RE: 3/2026/0587 – PLANE TREE FARM, CHIPPING ROAD - OBJECTION

[REDACTED]) write to formally comment, and object, to the application above which seeks planning permission for an earth banked slurry lagoon and the erection of a safety fence.

Planning application 3/2026/0587 - Construction of an earth banked slurry lagoon and associated landscaping, Plane Tree Farm, Chipping Road, Chaigley BB7 3LT

Figure 2: Application site context (red arrow to site for ease of reference)

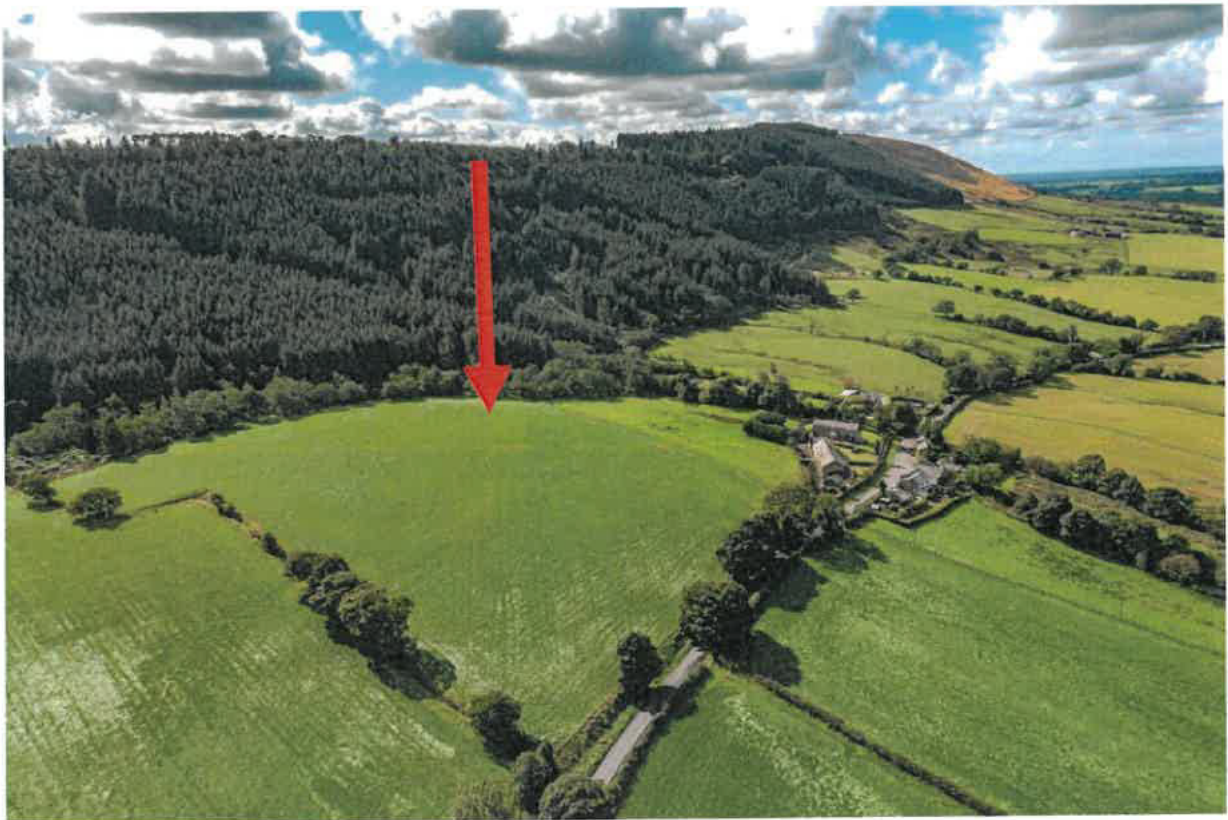
The current submission fails to demonstrate that the proposal has been sensitively located and designed to avoid harm to the statutory purposes and special qualities of the protected landscape. The submitted design and access statement acknowledges that the proposal is within the Forest of Bowland National Landscape, however, does little to go on and define or discuss the impact or justify the location at the furthest point of the farm, close to residential properties on the top of a hill which will be highly visible within wider views as can be appreciated from figure 1 and 2 above.
